**Town of Kittery
Planning Board Meeting
November 16, 2023**

ITEM 2—27 & 29 Wentworth—Site Plan — Preliminary Review

**Re: Site Plan Review
Tax Map 9, Lots 37 & 38
27 & 29 Wentworth Street
P5431**

TITLE:
SITE
PREPARATION
PLAN

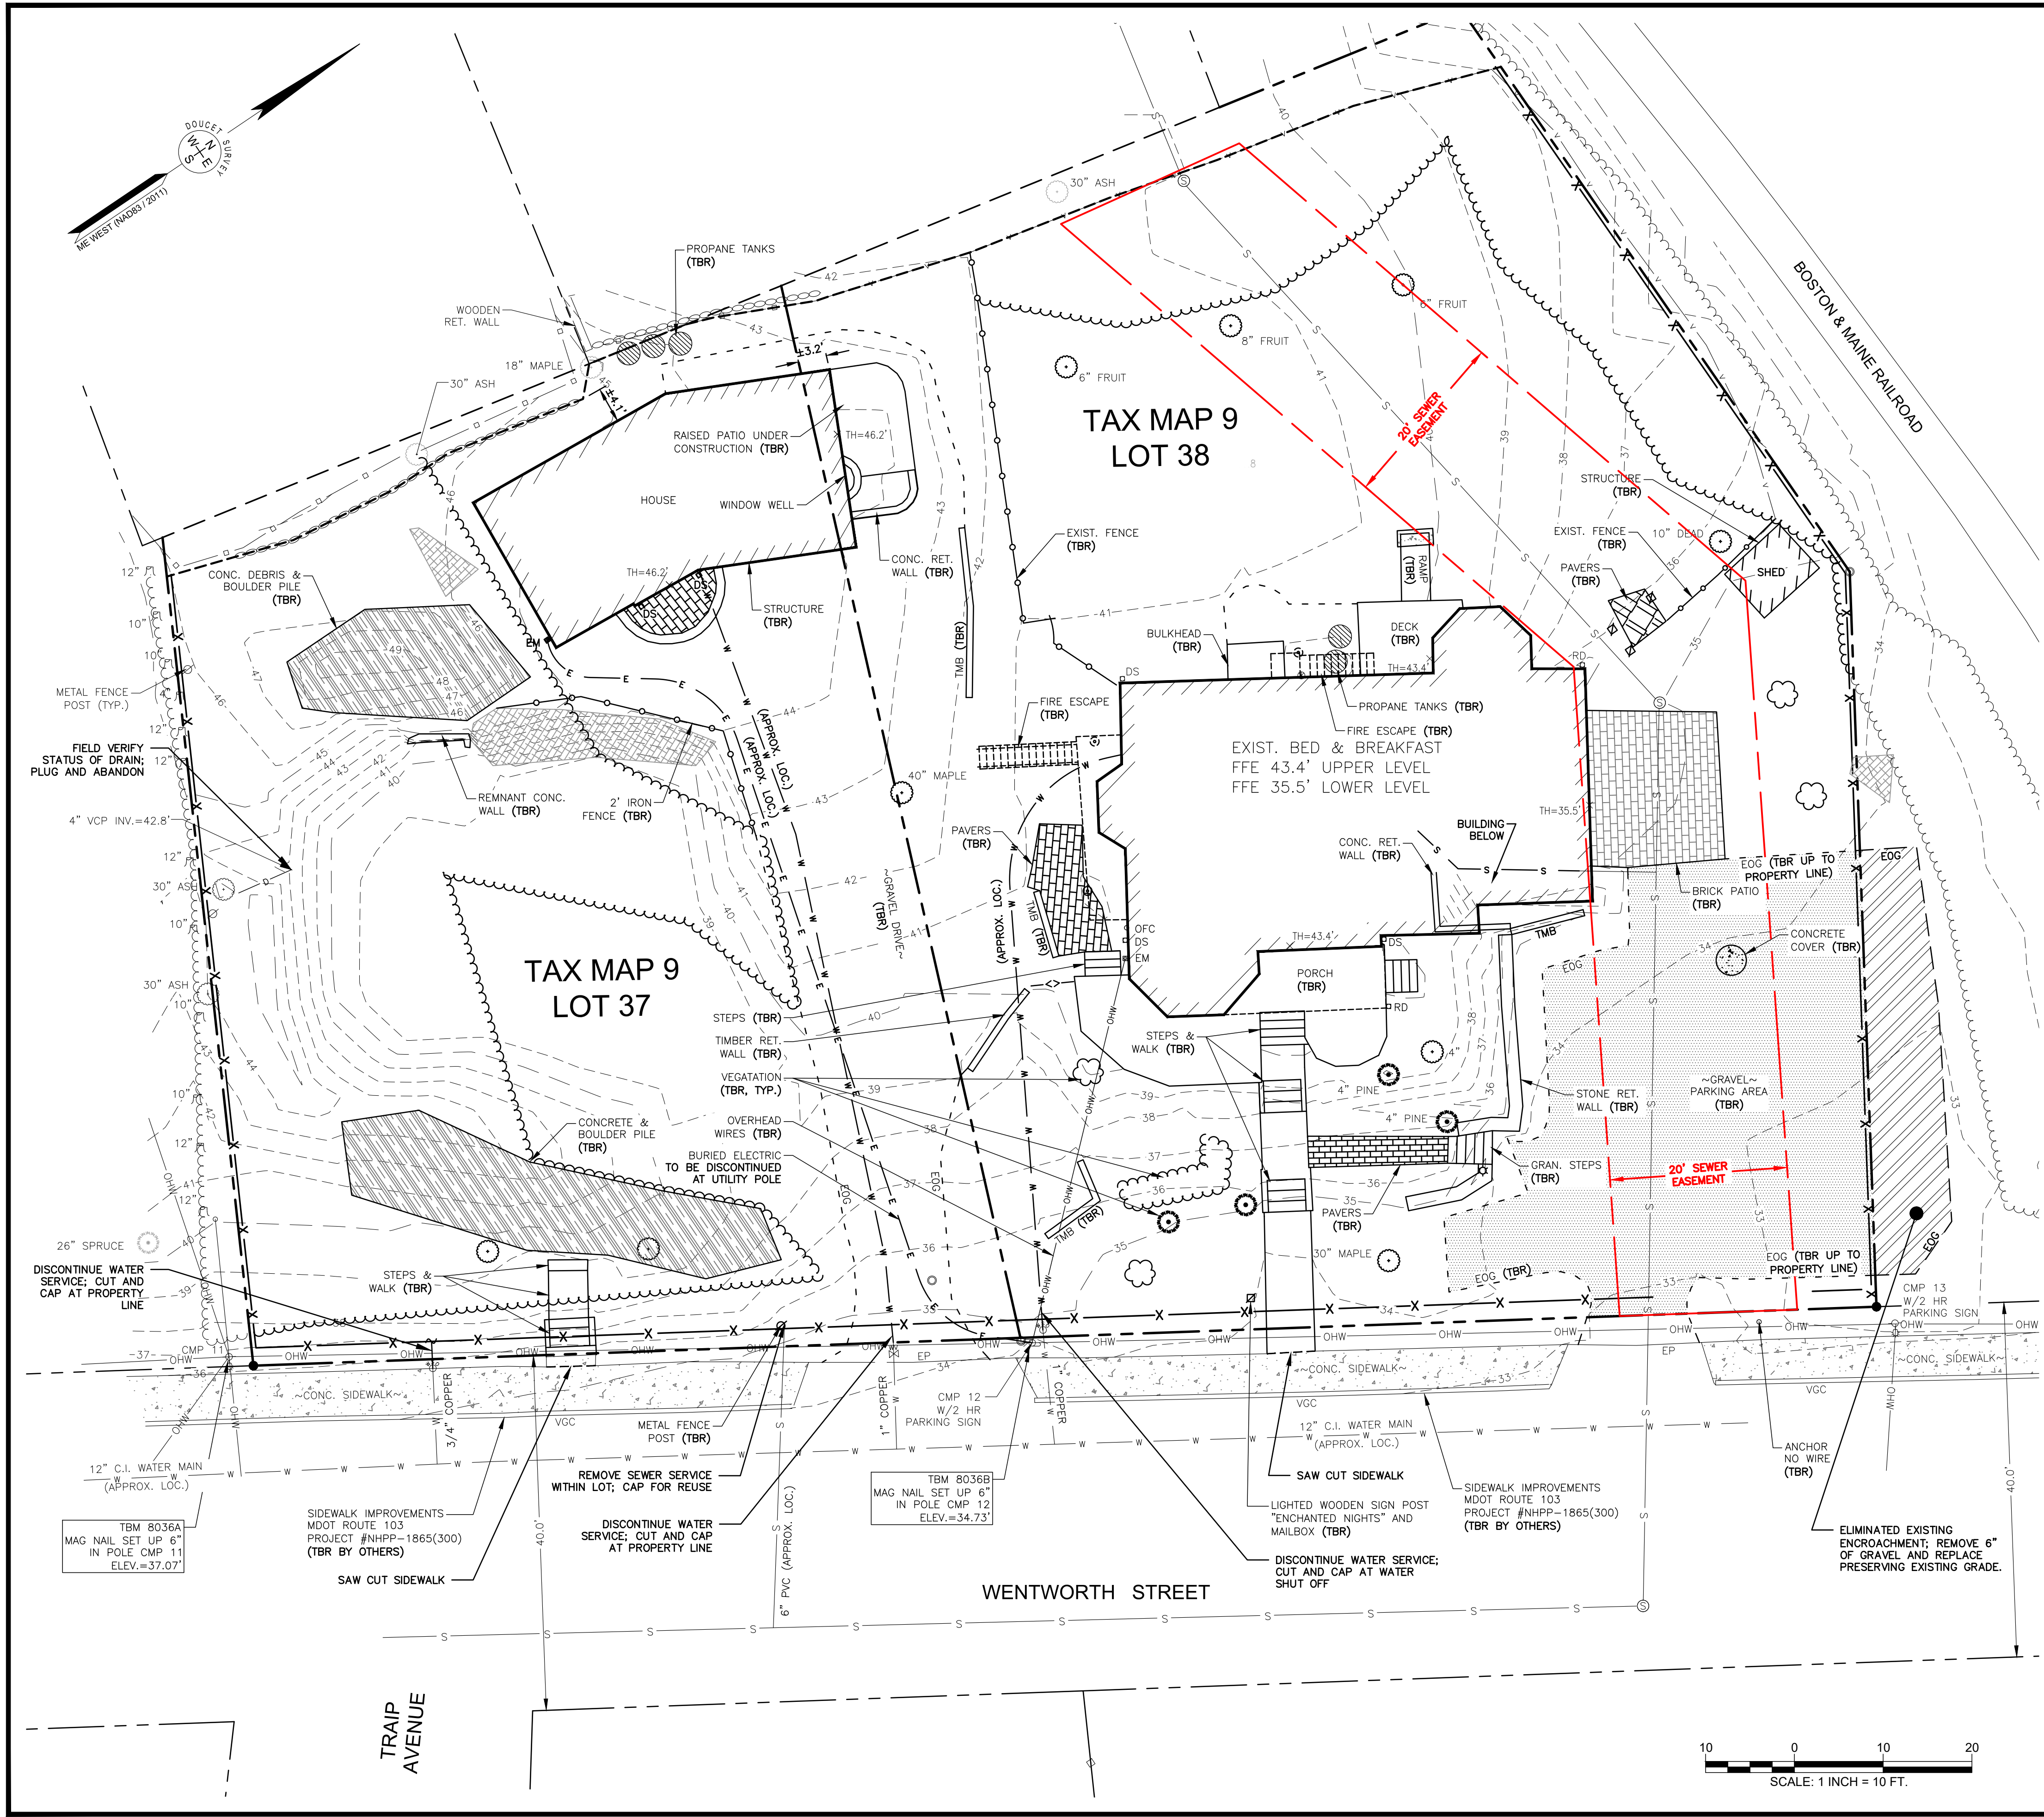
1. The dashed red line should be defined in the legend. **Altus: Added**
2. Are the steps and walk on Lot 37 to be removed? Please call this out on the plan. **Altus: Added TBR label.**

3. The leader buried electric to be abandoned has a misspelling. **Altus: Changed as noted.**
4. What are the details of abandoning the buried electric lines? Are they in conduit? Should this be cut and capped? **Altus: Add note "Service to be discontinued at utility pole". The underground conduits are in the work zone and will be removed as they are encountered.**

5. Verify that Kittery Water District wants the two old services cut and capped 2' beyond the property line and not at the property line or at the main. **Altus: Corrected notes per KWD request to leave existing curb stops and services to the property line left in place.**

6. Where are the existing sewer services located? What abandonment or demolition is planned for them? **Altus: Will confirm location with KSD and any standards they require for discontinuing sewer service.**

SITE PLAN

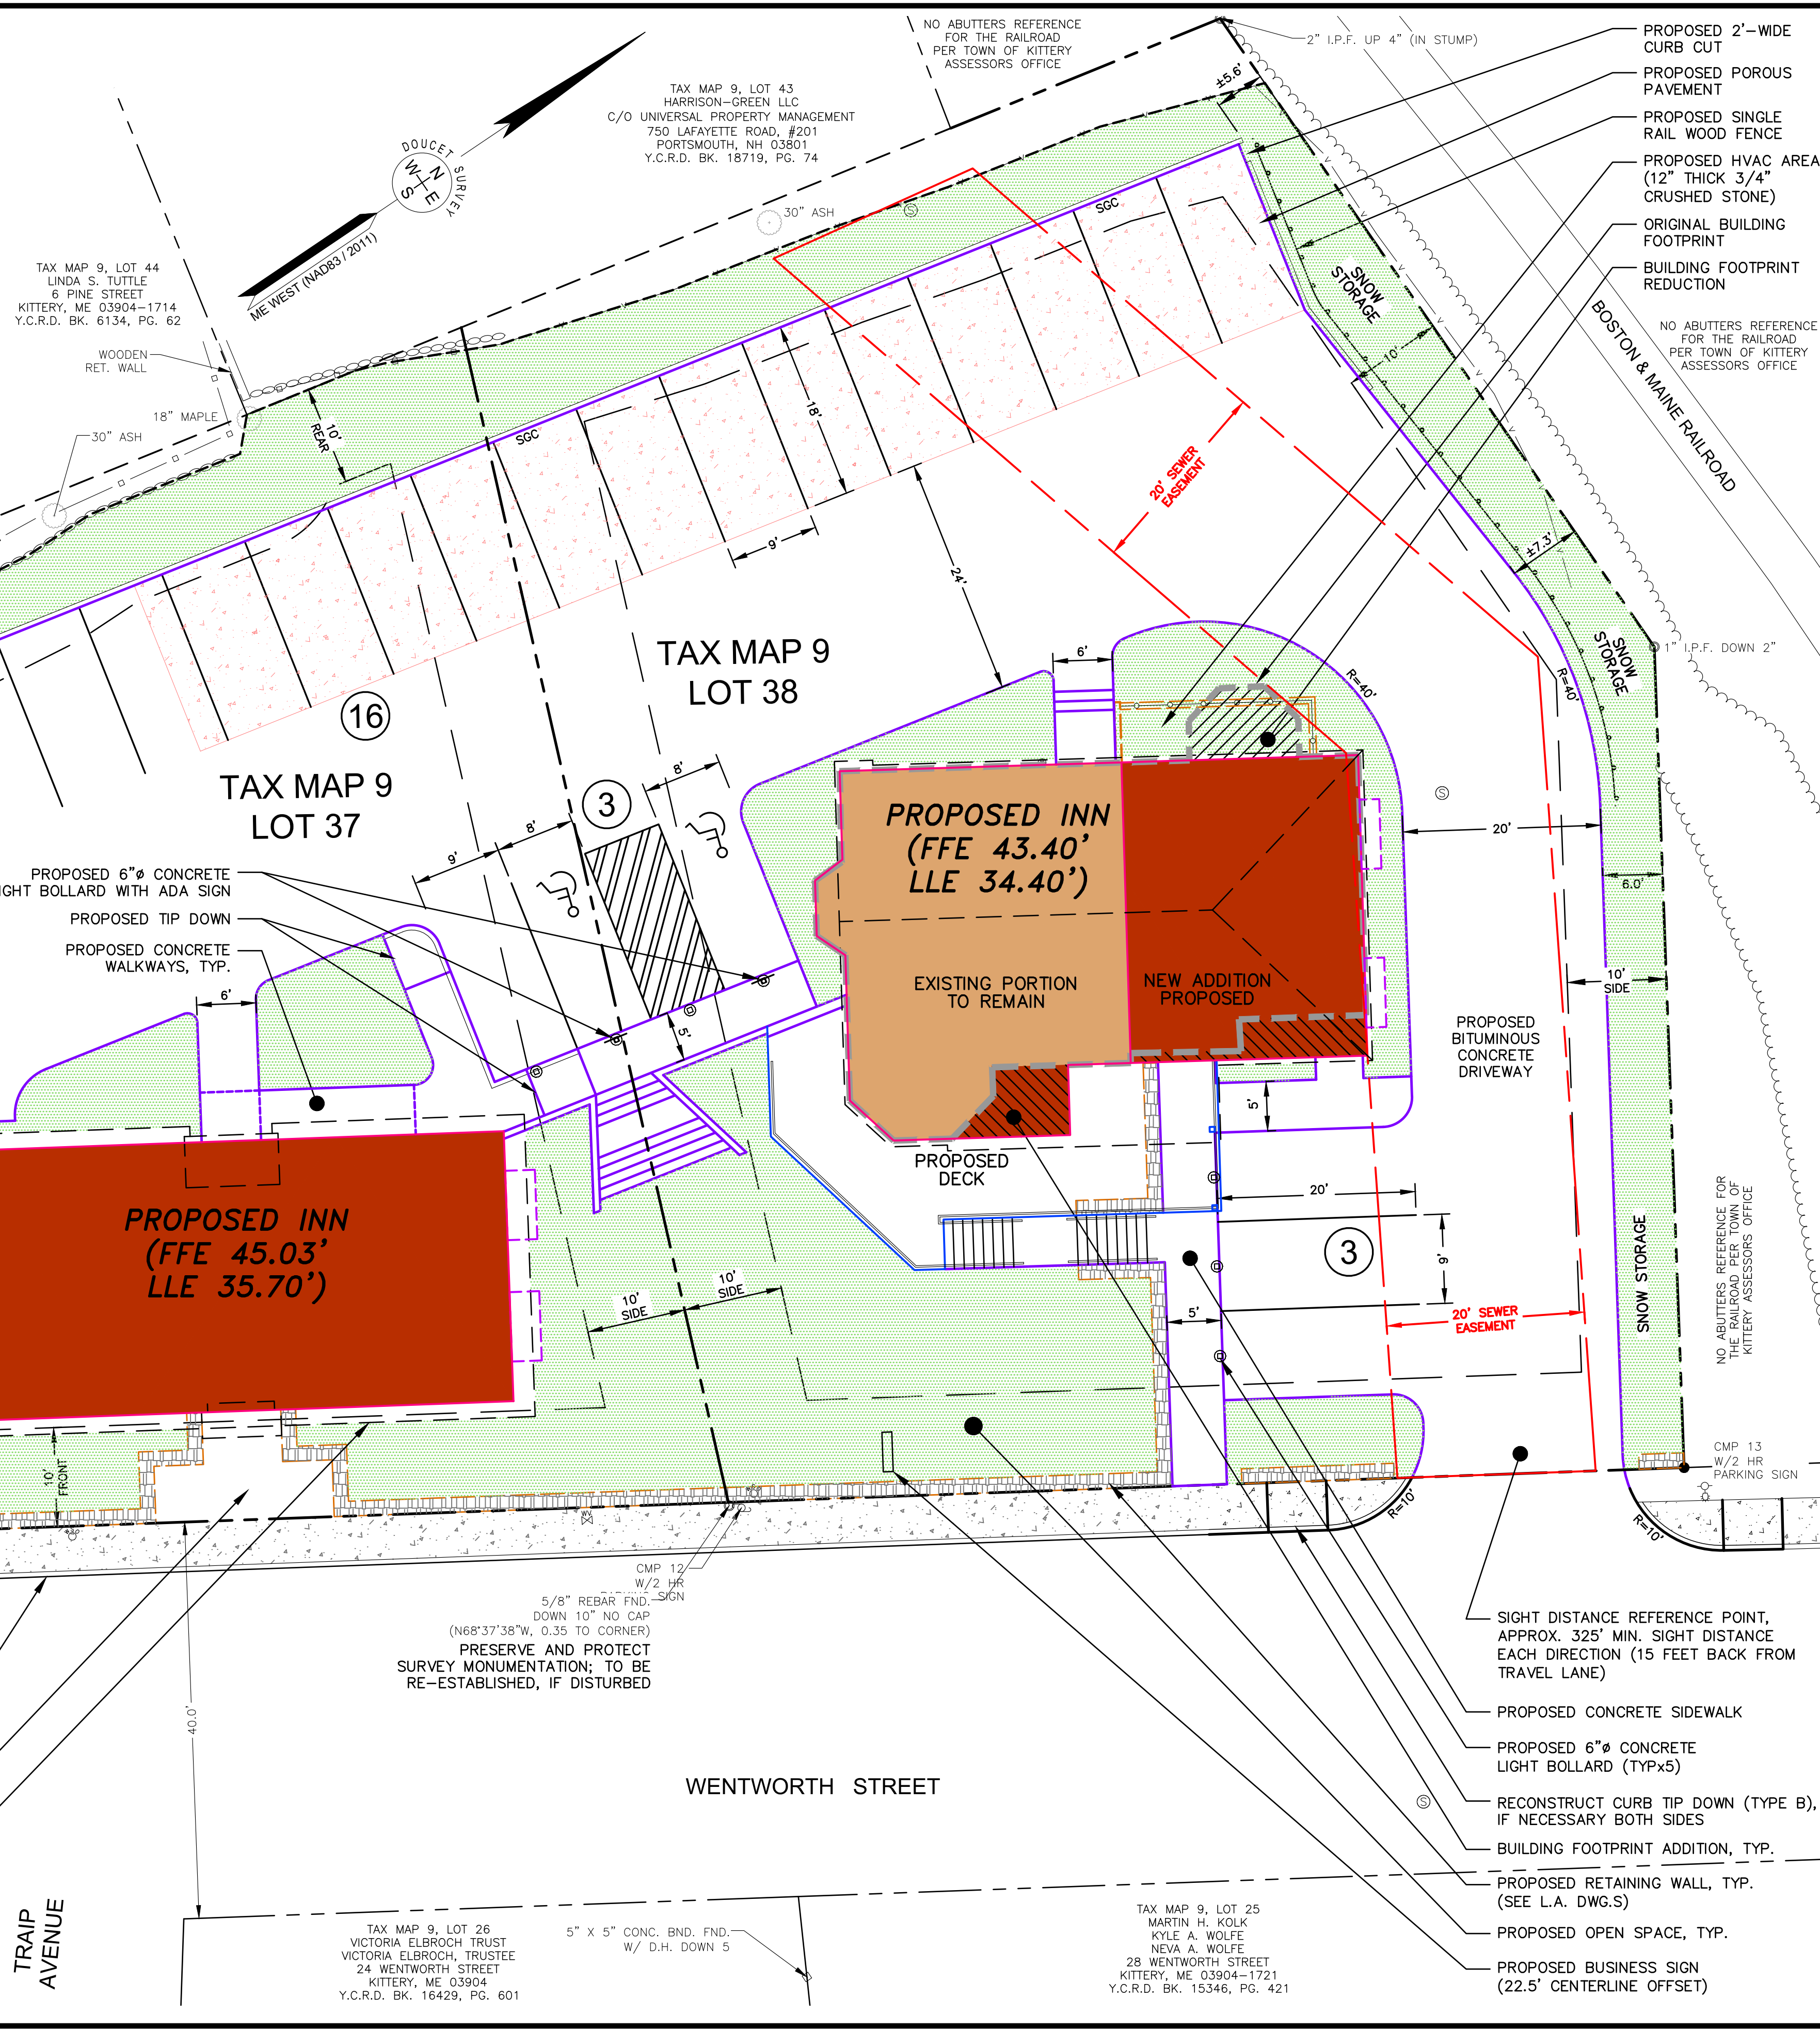
1. The colored/shaded/hatched areas and linetypes should be defined. **Altus: All colored areas are labeled.**
2. There are several symbols on the plan that are not defined. **Altus: Legend are shown on other sheets.**
3. Note 7 should be amended to remove information not pertinent to the plan. **Altus: Changed as noted.**
4. Lot 10 should be amended to read "Kittery Water District water". **Altus: Changed as noted.**
5. We note that part of the new building on Lot 38 is located in the sewer easement and that the sewer department has allowed it. **Altus: The new addition is within the existing building footprint. KSW has reviewed plans and has no issues.**
